Addendum No. 2
August 24, 2022

Project: **St. Mary Catholic School Addition & Remodel**
812 N. State Avenue
Dell Rapids, South Dakota 57022
Architecture Incorporated Project #2788

Scope of this Addendum:

SECOND FLOOR PLAN - DEMOLITION - PLUMBING & HEATING

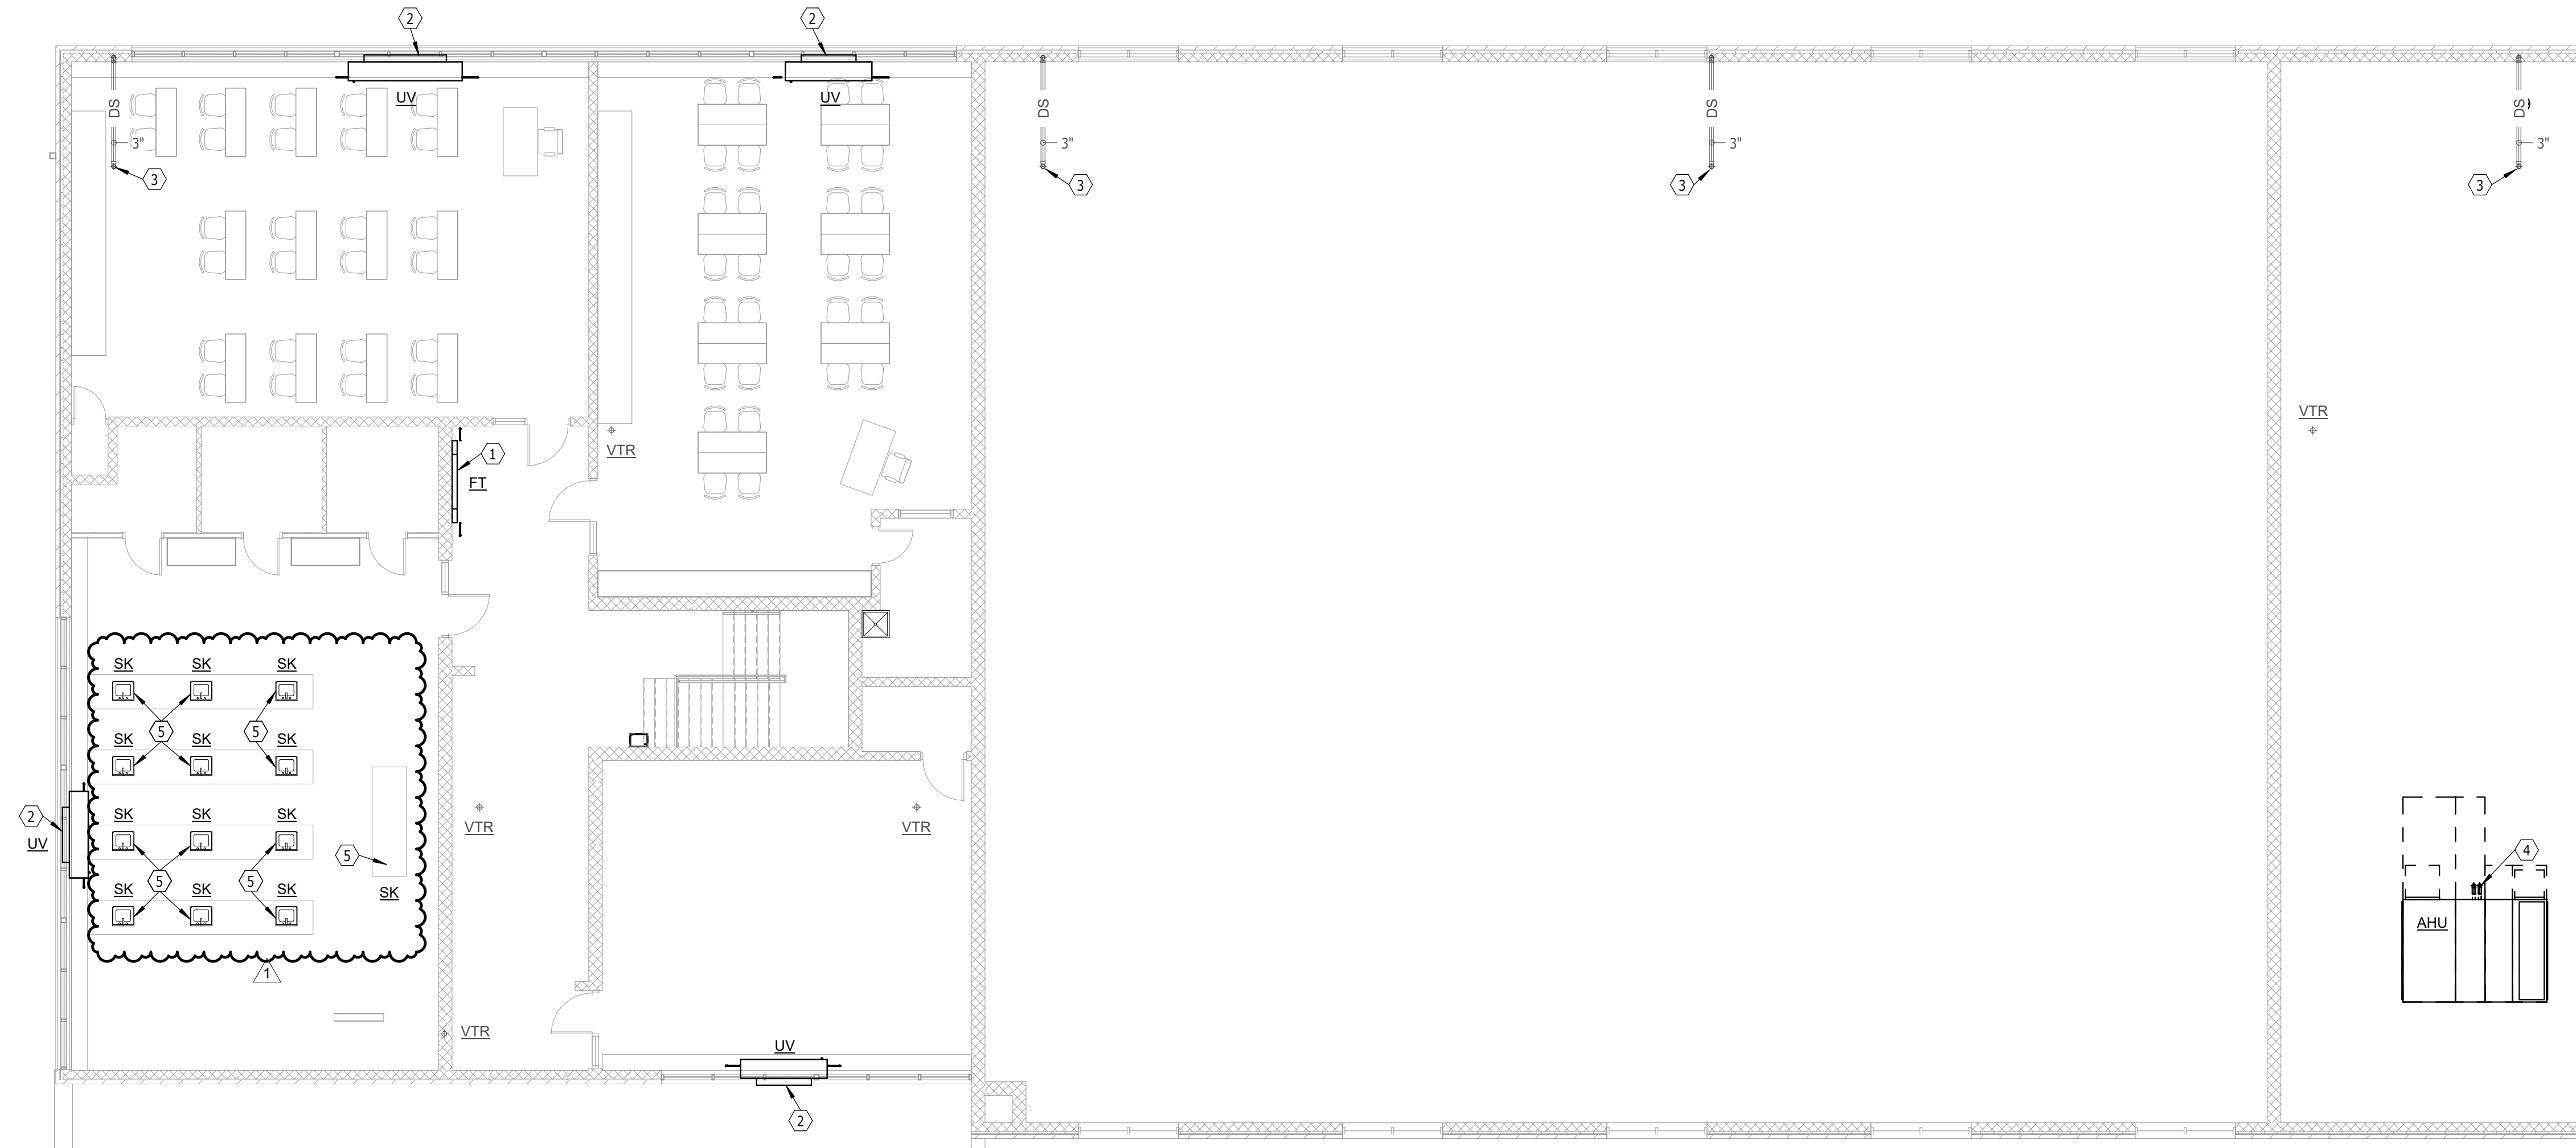
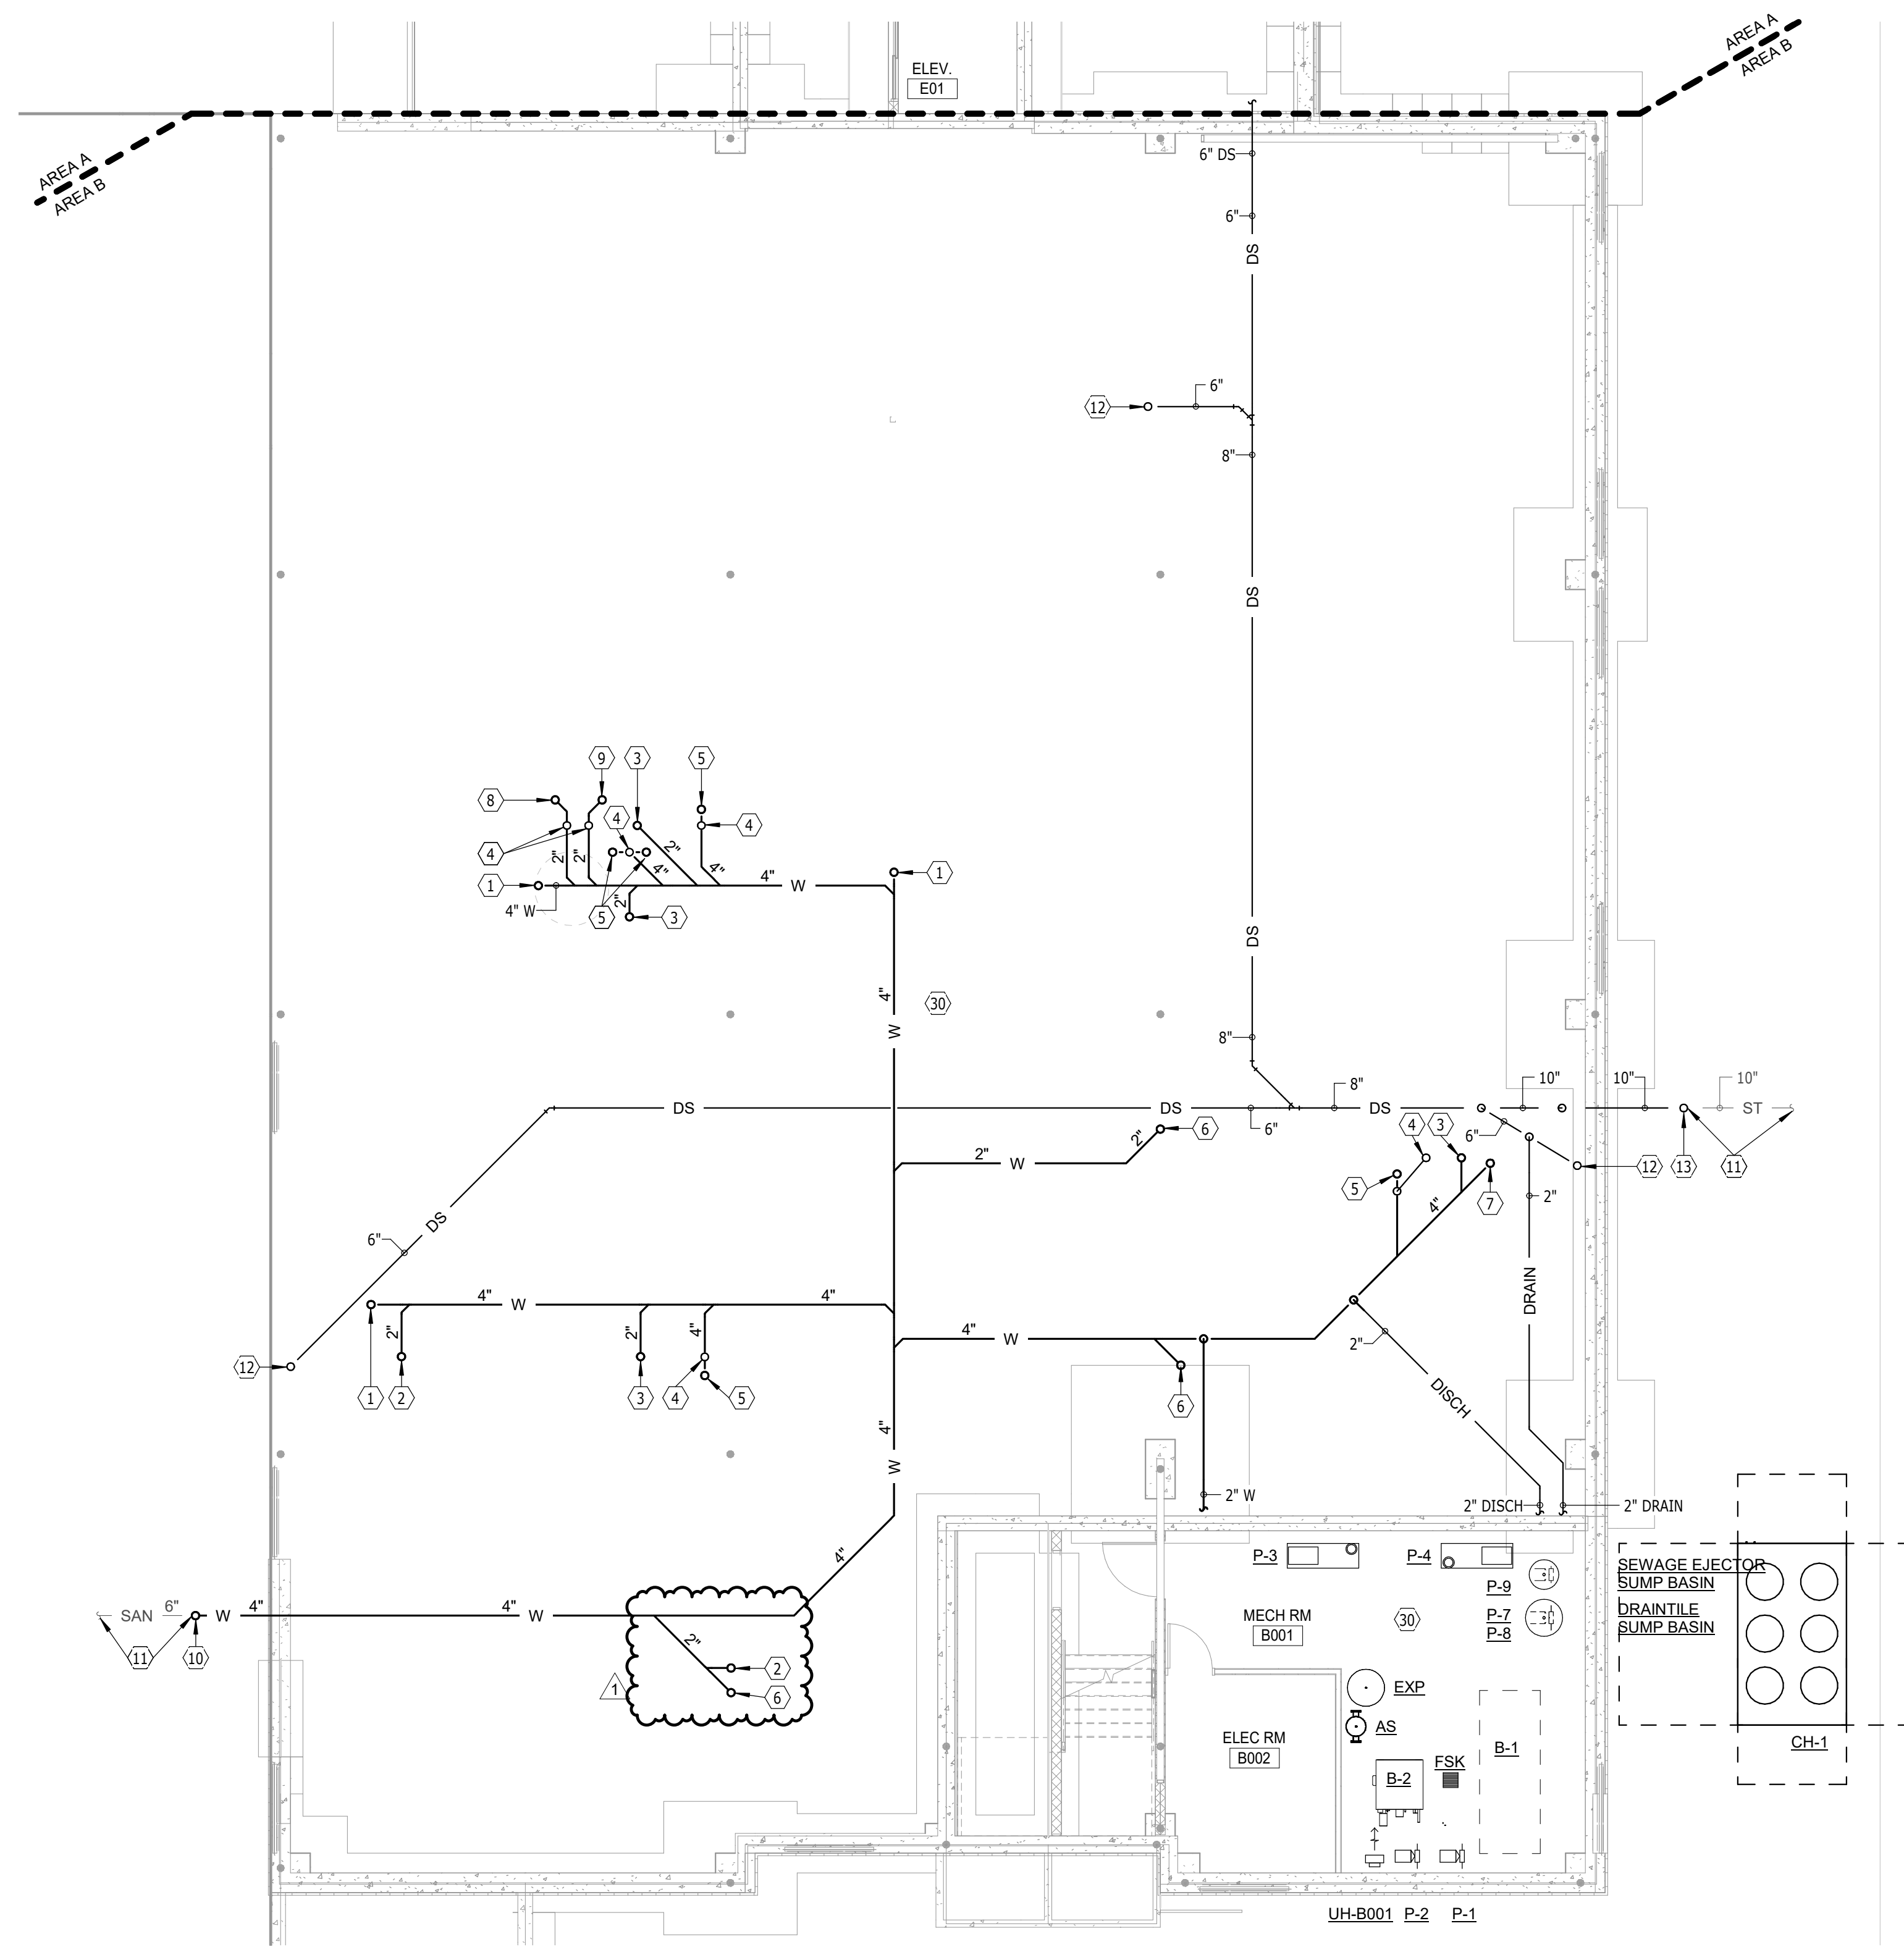
- a. Science Classroom – Remove sinks, gas turrets and associated piping under add alternate #5. See attached sheet.

UNDERFLOOR PLAN - AREA B - PLUMBING & HEATING
SCALE 0 4 8 12 16

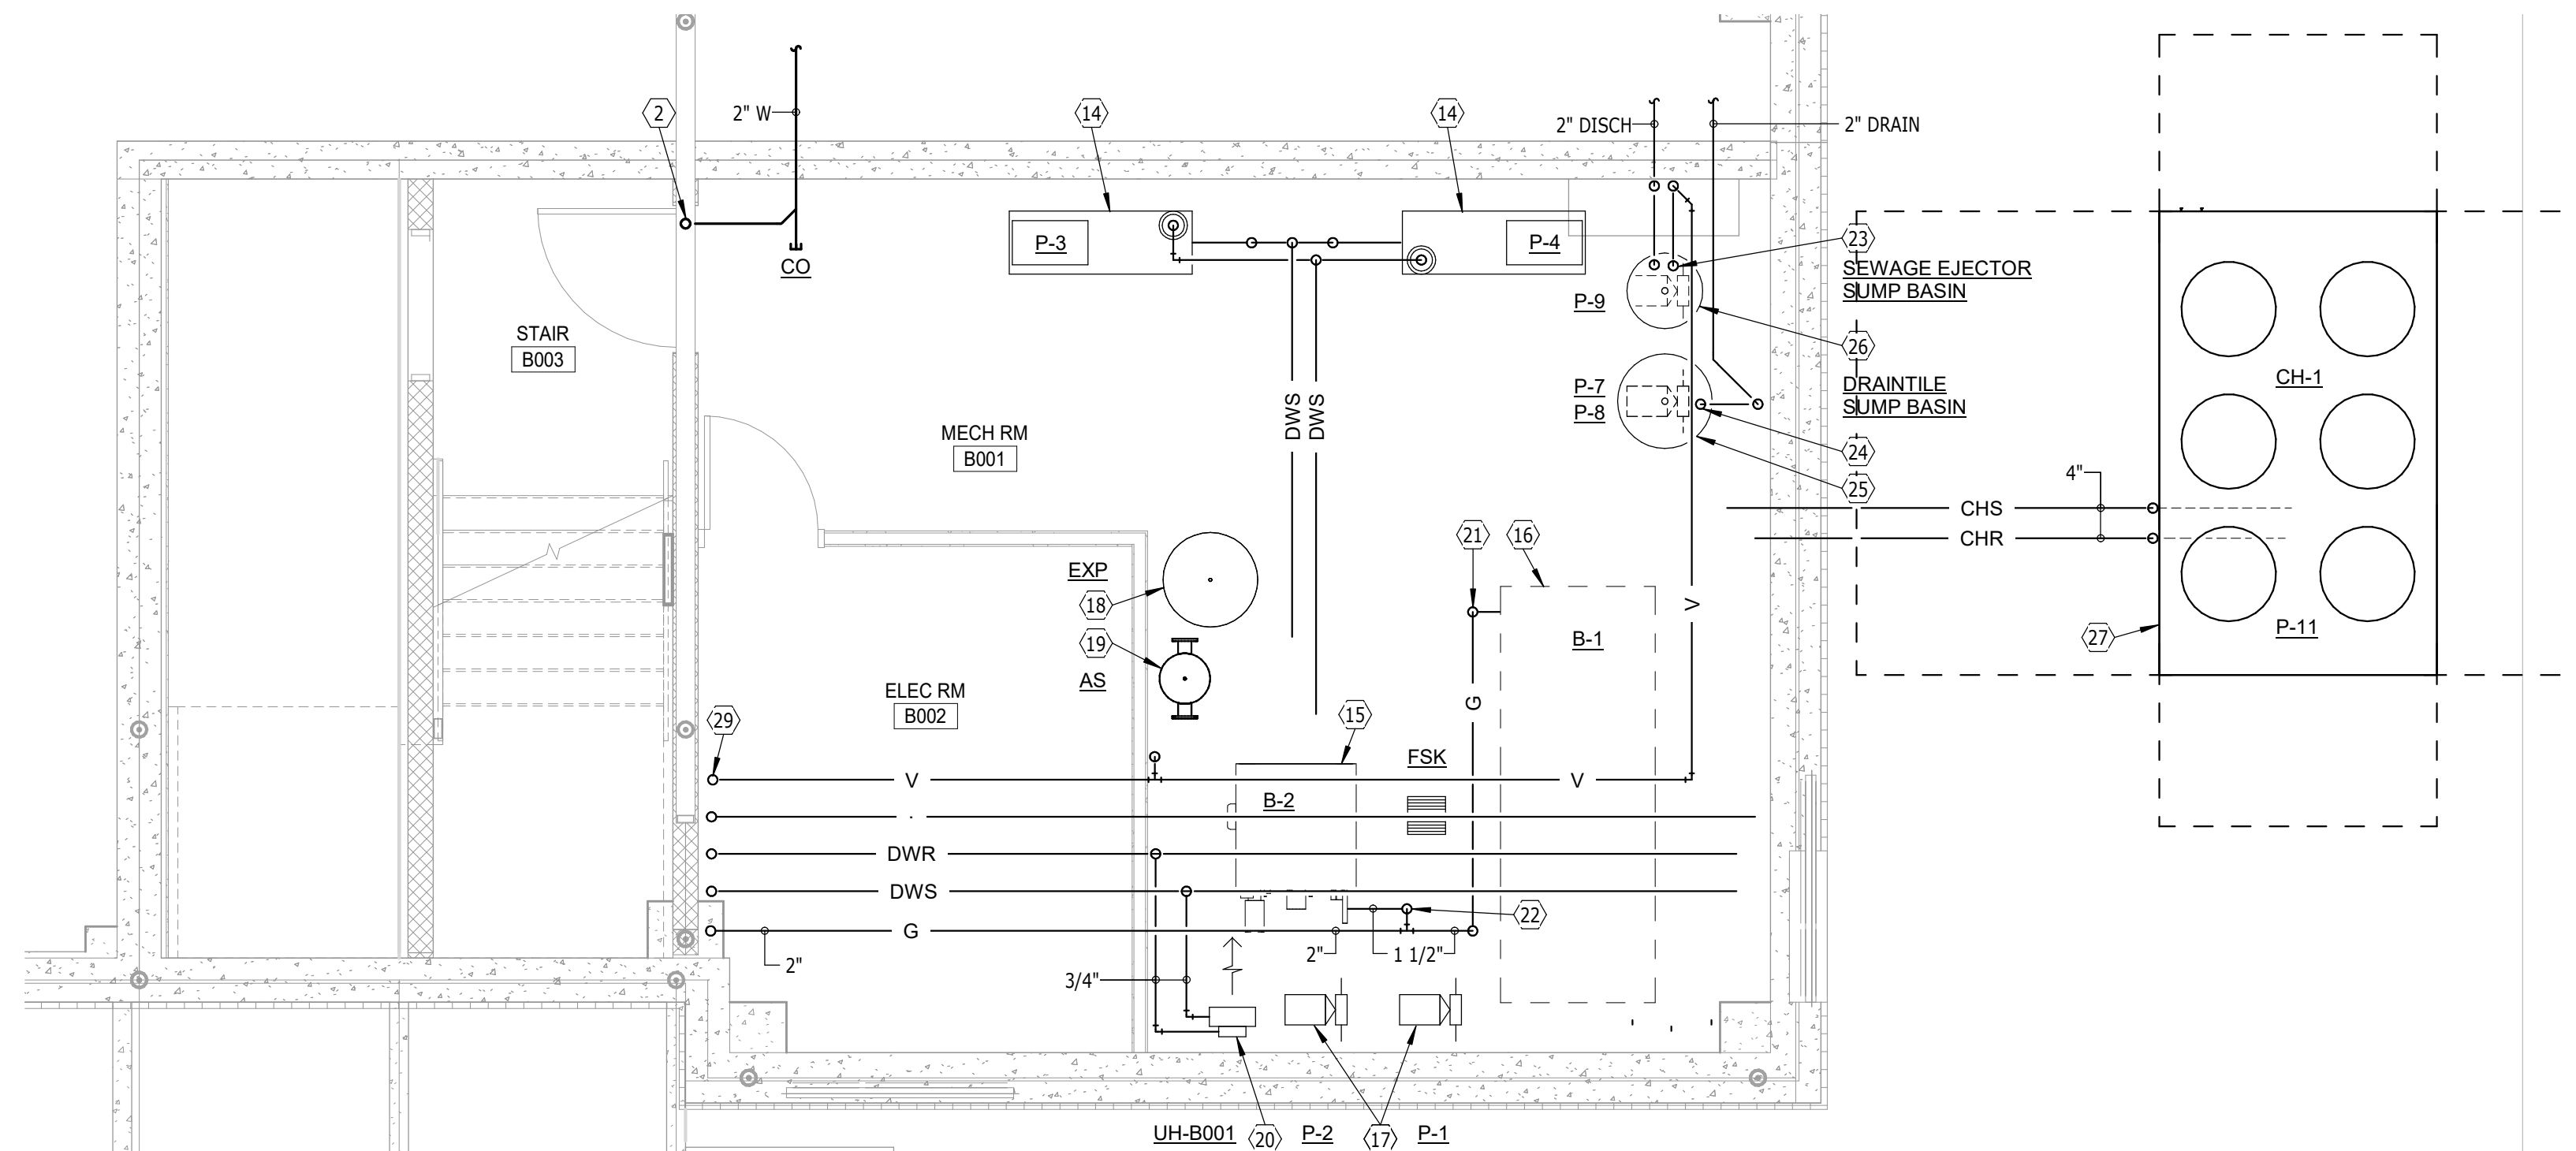
- a. Add electric water cooler & associated piping. See attached sheet.
